☒ Oil Well ☐ Gas Well ☐ Other8 Well Name and No.
SKELLY UNIT #914 (29742)2 Name of Operator
CHEVRON U.S.A. INC. (4323)9 API Well No
30-015-316653a Address
15 SMITH ROAD
MIDLAND, TEXAS 797053b. Phone No (include area code)
432-687-737510 Field and Pool or Exploratory Area
FREN; GLORIETA-YESO (26770)4 Location of Well (Footage, Sec., T., R., M., or Survey Description)
2310' FNL & 2310' FEL, SECTION 21, UL. G, T-17S, R-31E11 Country or Parish, State
EDDY COUNTY, NEW MEXICO

Skelly Unit #914
Chevron / COG Operating LLC
30-015-31665
June 21, 2011
Conditions of Approval

SKELLY UNIT #914 DEEPENING PROGRAM

12. Summary Drilling and Completion Program

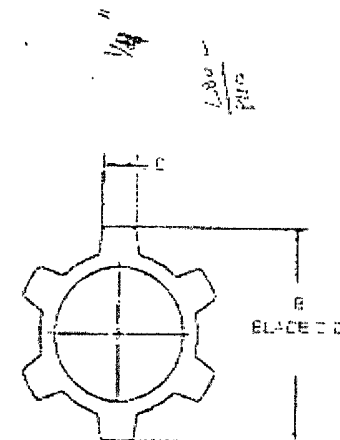
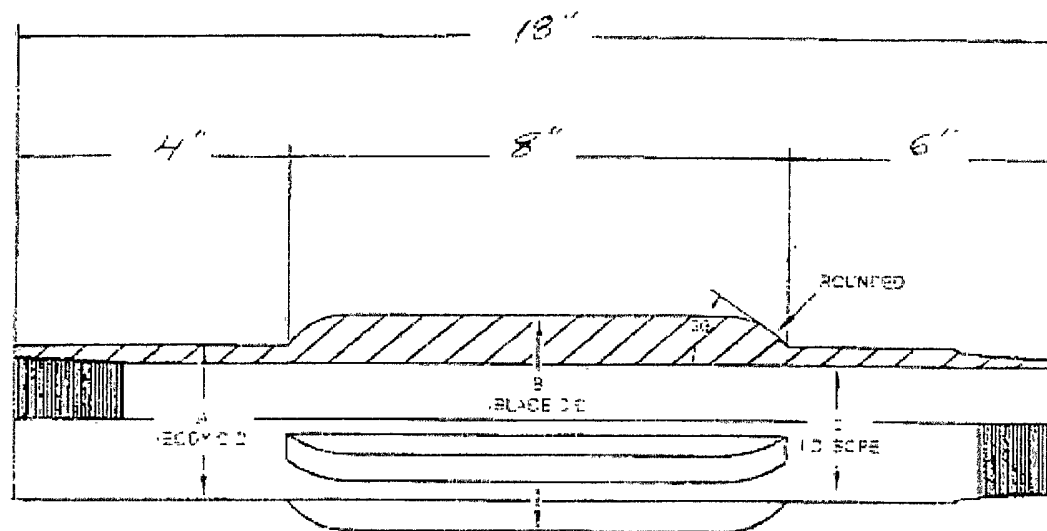
- d) Test casing as per Onshore Order 2.III.B.1.h.
- e) It is recommended that the top of the lead cement for the 4" casing be 100' minimum above the top squeezed shot, since the perforation length is extensive (276'), and there is no pressure testing or drawdown testing planned for the squeezed perforations.

- f) The planned depth for setting the DV tool should be revised to $\pm 4756'$, or shallower; which is above the top of the open perforations to be squeezed. By doing so, all of the squeezed perforations will be cemented behind the 4" casing. When plugged, a cement plug will be required across this tieback.

- g) The proposed centralizer locations for the shoe, the perforated intervals, and the liner top are acceptable, and will provide necessary centralization in the liner lap, without a liner hanger.

- h) The 4" casing will be backed off above the DV tool, now being located at $\pm 4756'$.
- i) If cement does not circulate from the DV tool, the appropriate BLM office is to be notified. In that event, Operator to recommend the alternate method of confirming TOC.
